DOCKET NO. E-100, SUB 128

Investigation of Integrated Resource
Planning in North Carolina – 2011

DUKE ENERGY CAROLINAS, LLC'S
REPLY COMMENTS

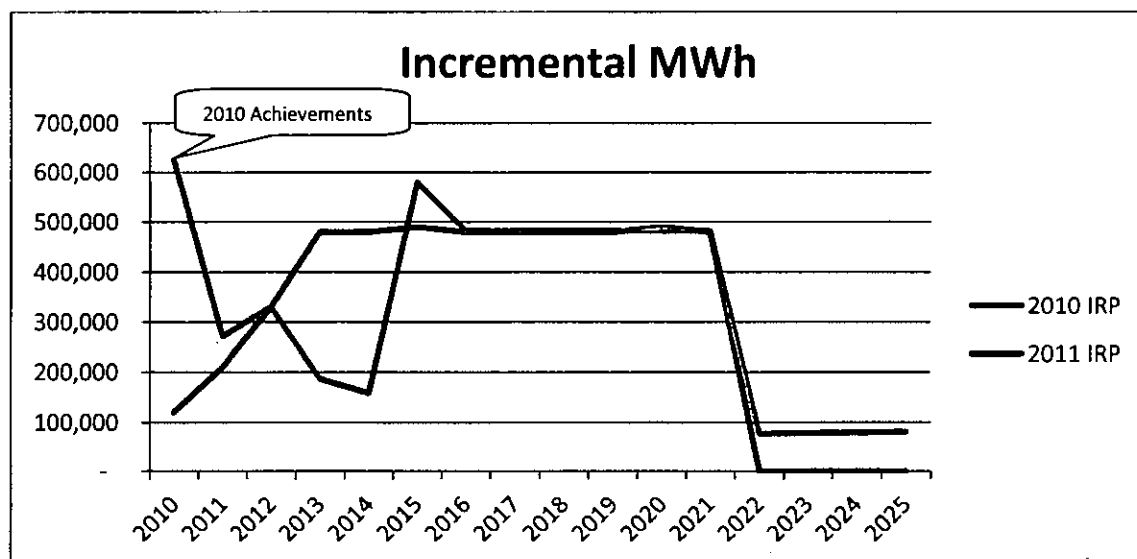
14. SACE next asserts that Duke Energy Carolinas has failed to adequately consider energy efficiency as a resource option in its 2011 IRP. SACE initially applauds the Company for its program performance in 2010, but then states that Duke Energy Carolinas has undervalued energy efficiency in its 2011 IRP. SACE Comments at 7. SACE alleges that in its 2011 IRP, in contrast to the Company’s higher-than-expected performance in 2010, it has reduced the projected long-term impact of energy efficiency from its 2010 IRP by 11% without a clear explanation. SACE Comments at 7-8.

15. As an initial matter, SACE’s contention that the Company’s projections for EE achievements have decreased by 11% in its 2011 IRP is simply incorrect. As time moves forward, the Company achieves energy efficiency load impacts, which show up as reductions in the metered load of customers in the historical load data. Since the Company’s load forecast

relies on historical load data in the development of its forecasting models, the historical load impacts from past EE achievements are already reflected and incorporated into the load forecast. Therefore, the actual 2010 accomplishments (shown as a projection in the 2010 IRP) have been embedded in the 2011 load forecast and are not included a second time in the energy efficiency data shown on the 2011 projections since that would double-count those 2010 impacts. In addition, Table 4.A of the 2011 IRP includes energy efficiency program growth beyond 2021 that was not assumed in the Base Case for the 2010 IRP. In fact, the cumulative energy efficiency projections over the planning period have actually increased in the 2011 IRP rather than decreased.

Base EE Case – 2010 vs Adjusted 2011 IRP

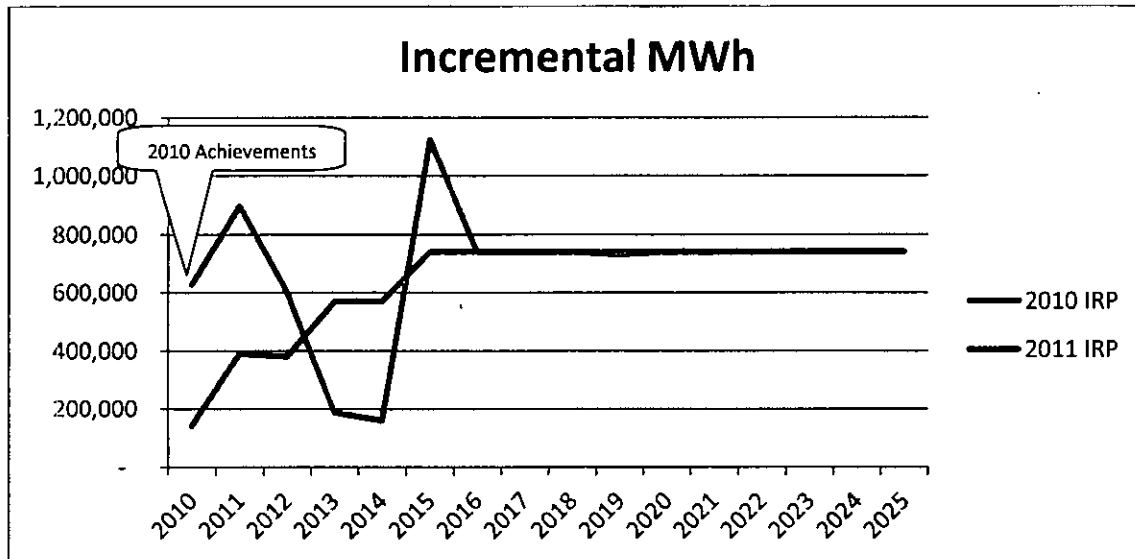
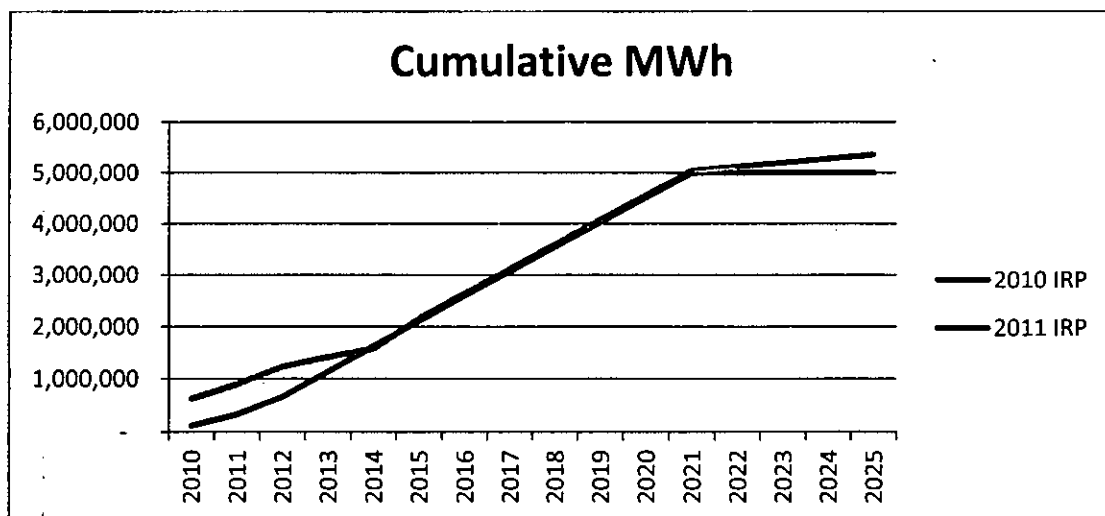
18. As illustrated in the charts below, the use of the Company's specific projections for the first 4 years results in a difference in the timing of the savings, i.e. slightly more incremental achievements in 2011, roughly the same in 2012, lower in 2013 and 2014, then higher in 2015. As noted by SACE, the Company characterizes this variability as a reflection of the timing of the expected roll out of new products, as well as drop off in participation of existing products (e.g. CFLs), as well as the relative impacts gained through participation in the new products and lost through expected reduction in participation in existing products.

The 2011 IRP EE forecast is based on Duke Energy Carolinas' specific projections derived from its additional field experience with the programs, and represents how the Company expects to implement programs. SACE may be dissatisfied with the up-and-down nature of the Company's expected achievement of incremental impacts, but a smoother projected deployment curve would not mean the projections are any more accurate or meaningful. Duke Energy Carolinas has been gaining valuable and incremental improvements in knowledge regarding the manner in which its programs can be effectively deployed and the Company intends to utilize such knowledge improvements as it continues to expand and refine its program portfolio.

19. SACE also conveniently fails to acknowledge that the Company's forecast for EE achievements still represents a commitment to achieve a cumulative EE reduction in the 2011 IRP equivalent to that forecasted in the 2010 IRP (when the 2011 IRP is adjusted to include actual megawatt-hour ("MWh") achievements from 2010). As mentioned above, it is important

to note that while the incremental achievements by year are different between the 2010 and 2011 IRPs, the cumulative achievements in both the Base Case and High DSM Case in the 2011 IRP are relatively the same as the cumulative achievements in the 2010 IRP when the actual achievements for 2010 are included in the 2011 IRP Tables. As actual EE impacts are achieved through the implementation of the Company's EE and DSM programs, those impacts become part of the historical achievements that are automatically incorporated into the base load forecast. To include the 2010 results in the projected 2011 IRP EE impact forecast (Table 4.A of the 2011 IRP), when those impacts are already reflected in the load forecast, would double-count the impacts. To correctly compare the projected EE impacts between the 2010 and the 2011 IRP, one would need to adjust the 2011 IRP tables to include the actual achievements from 2010, approximately 620,000 MWh. The Cumulative MWh charts below illustrate the consistency of the long-term cumulative forecasts from 2015 and beyond. The cumulative impacts for the Base Case are actually higher beyond 2021 in the adjusted 2011 IRP because the 2011 IRP includes growth in the conservation programs beyond the year 2021 where the 2010 IRP assumed no growth.
